# **Responses to DNR comments on mining permit application. November 11, 1983**

November 11, 1983

## Responses to DNR Comments on the Mining Permit Application

(FIGURE FOR RESPONSE TO COMMENT NO. 38.)

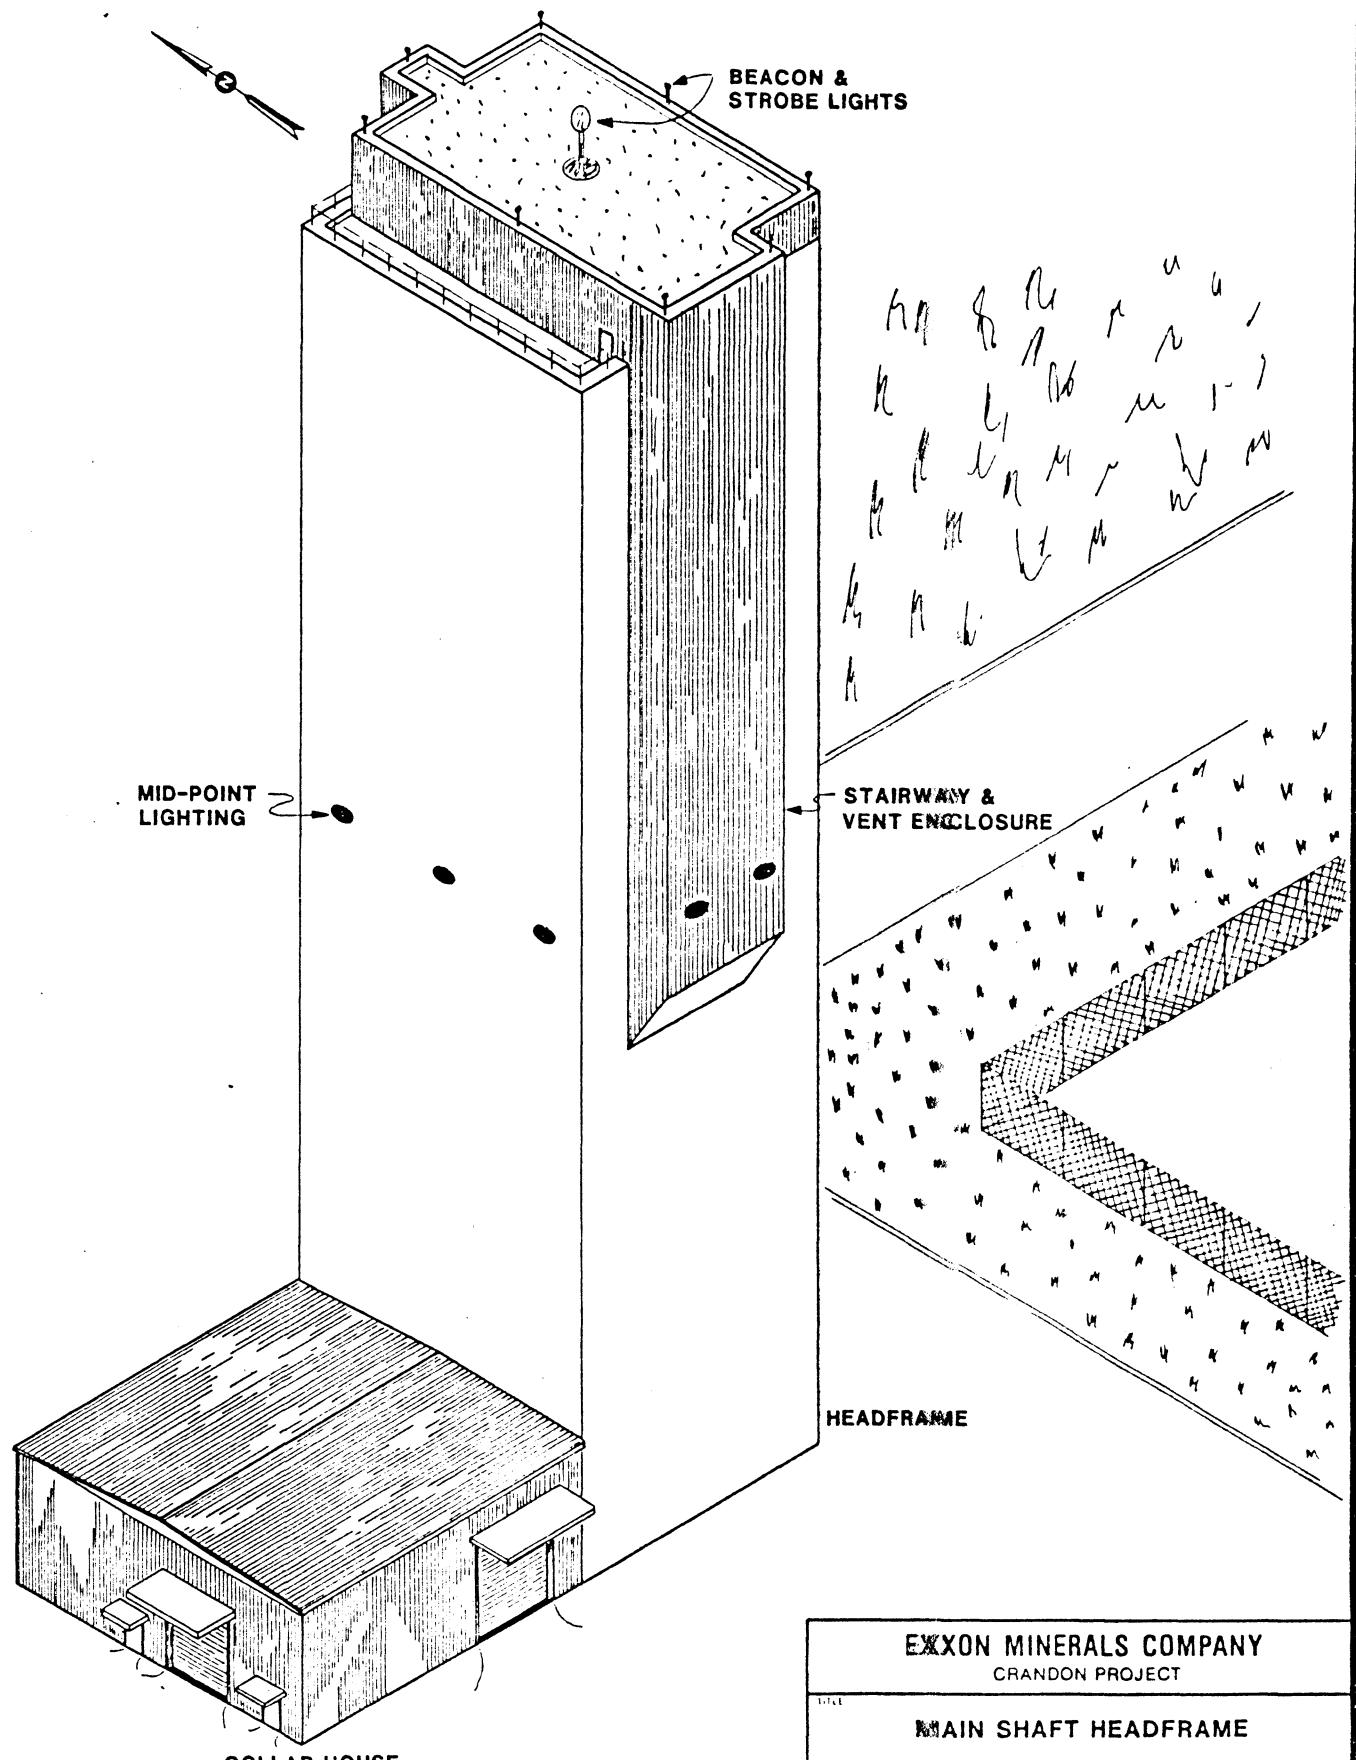
Section 2.1.1.1, Headframe - The external appearance of the headframe should be more thoroughly discussed.

The Crandon mine main production and service shaft headframe will basically be a slip-formed rectangular concrete tower 78 m (258 feet) high. The only appurtenances will be the metal siding enclosures for tower access and ventilation. These include a ventilation penthouse, return air and stairway enclosures on the upper half of the tower's north and south exterior walls and the shaft collar house at ground level. An artist's conception of the headframe is presented in the attached figure.

Due to the proximity of the Crandon airport, the Wisconsin Aeronautics Administration requires installation of 360 degree unlimited distance visibility lighting on the headframe. The planned air traffic safety lighting will include white strobe lights (60 flashes/minute) atop the headframe for daylight hours, and a 300 mm (11.8 inches) flashing red beacon atop the headframe combined with red non-flashing structure mid-point lights at night.

(FIGURE 1 FOR RESPONSE TO COMMENT NO. 96.)

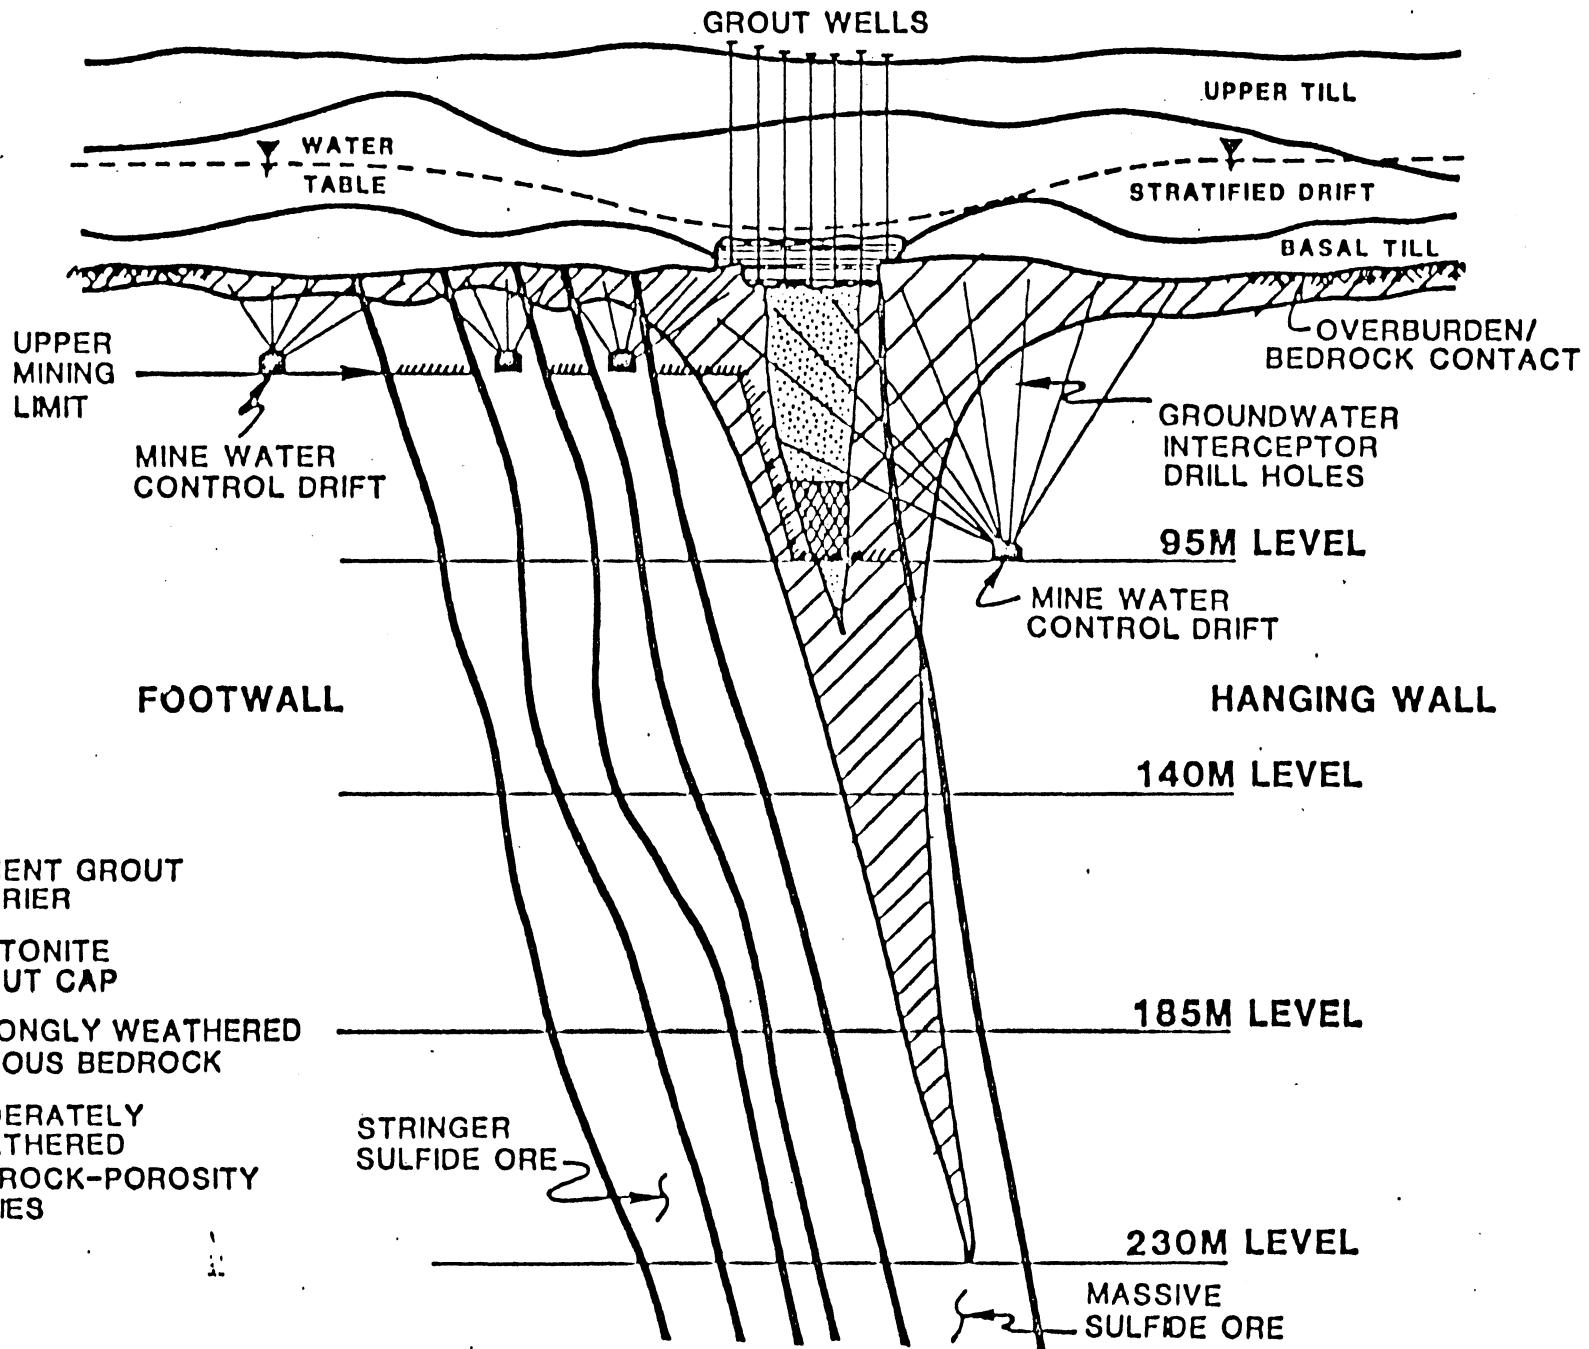
Section 3.2.4.3, Underground Development - (1) The discussion of grouting the bedrock-overburden interface is inadequate. Details on the location of grouted sections, thickness of grout layers and total amount of grout to be injected must be presented along with a detailed plan of construction. (2) A similar discussion of the specifications and construction of the groundwater interceptor system is also necessary. Diagrams and cross sections of these two systems would be extremely beneficial. What will the temporary water containment facilities consist of?

At areas of the orebody subcrop where saturated glacial sands are in contact with porous weathered bedrock, bentonite grout would be injected through surface wells (Figure 1 attached). Klohn Leonoff has recommended a descending two stage technique. The first stage would place 4.5 m (15 feet) of grout in the glacial overburden immediately above the bedrock. A second grouting phase would then be conducted in the upper 4.5 m (15 feet) of the weathered bedrock. The resulting layer of reduced permeability material, or grout blanket, would then be 9.0 m (30 feet) thick (Figure 2 attached).
